## Device Errata

**MPC860ADS Application Development System  
Board Versions ENG, PILOT, REV A**

February 5, 1997

PROJECT :	MPC860ADS	REV :	A	SHEET	2	OF	16
ENG :	YAIR LIEBMAN	BLOCK :					
CHK :		DESCRIP :	ADDRESS, DATA & STROBE BUFFERS

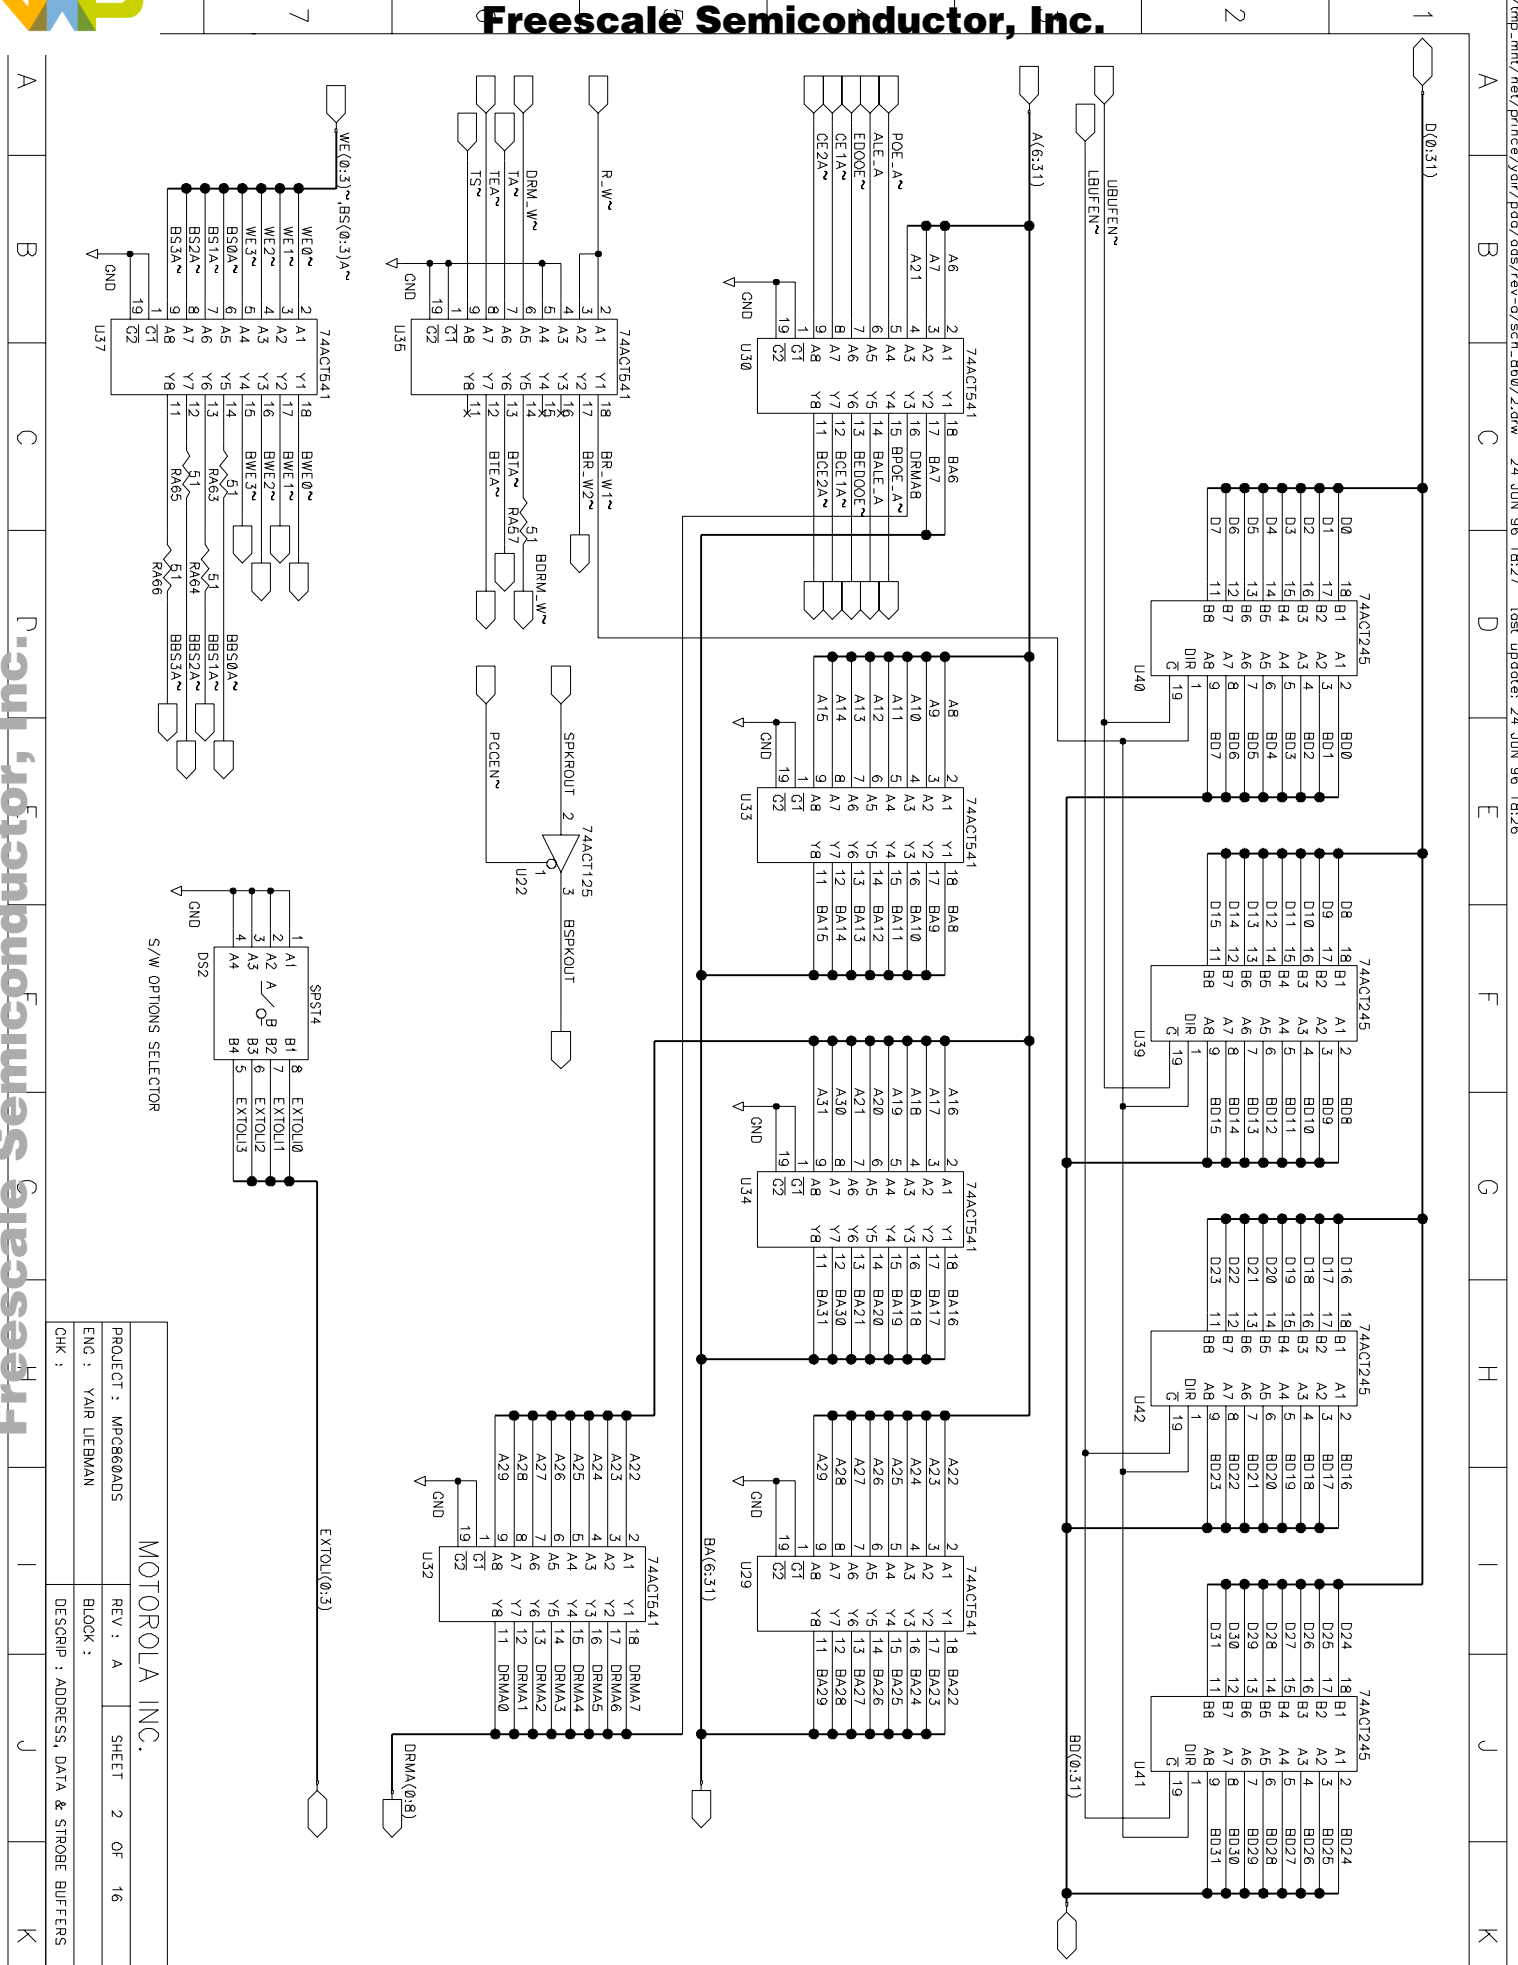
Impedance mismatch problems with some SIMMs causes spikes on the  $\overline{\text{RAS}}$  and  $\overline{\text{CAS}}$  lines which can cause problems with interfacing to DRAM.

Insert the following series damping resistors:

- (1) 51ohm series resistors from the output of RAS2, RAS1DD, and RAS2DD of the Mach220 at U10 [U9 of ENG board revision]
- (2) 470ohm pull-down resistor on RAS1 output of the Mach220 at U10 [U9 of ENG board revision]
- (3) 51ohm series resistor from the output of BDRM\_W of the 74ACT541 at U35 [U33 of ENG board revision]
- (4) 51ohm series resistors from the outputs of BBS0A, BBS1A, BBS2A, and BBS3A of the 74ACT541 at U37 [U35 of ENG board revision]

Updates for REV A schematic sheets effected by this are included with this errata list.
